ADDRESS . . : 164 SHERMAN PINES DR
CONTRACTOR :
OWNER . . : HOMETOWN DEVELOPERS LLC #14
PARCEL . . : 08-0655- - -0118- -50-
APPL NUMBER: 07-50017243 CP NEW RESIDENTIAL (SFD)
DIRECTIONS : SHERMAN PINES #14
401N TO SHERMAN PINES DR LEFT TO LOT ON
RT. JDAVIS

Reference: Framing Observations
Lot 14, Sherman Pines
Fuquay-Varina, NC
Project No.: 07AH-261

Reference: Framing Observations
Lot 14, Sherman Pines
Fuquay-Varina, NC
Project No.: 07AH-294

16" TJI® 360 @ 16" o/c

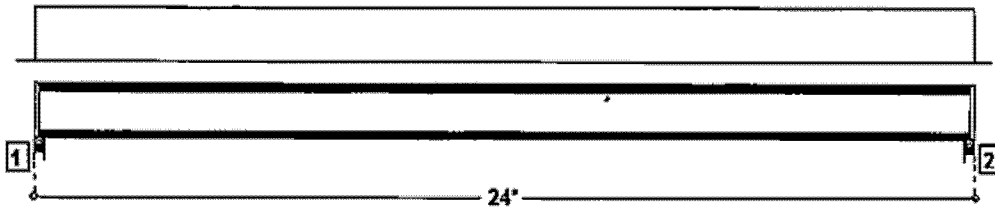
- 1) Observation of over-framing at the front three gables in-lieu of the plan specified structural valleys.
- 2) Analyze (2) 11-7/8" LVL at center dormer supporting the main rafters and ceiling joists.
- 3) Analyze 16" TJI floor joists at 16" O.C. in the garage.

- 1) Based on our observations and analysis, the over-framing at the front three dormers in-lieu of the plan specified valleys are adequate as constructed to support the anticipated loading conditions. No further action is required.
- 2) Based on our observations and analysis, the (2) 11-7/8" LVL at the center dormer is adequate to support the anticipated loading conditions. No further action is required.
- 3) Based on our observations and analysis, the existing 16" TJI floor joists at 16" O.C. in the garage are adequate to support the anticipated loading conditions. No further action is required.
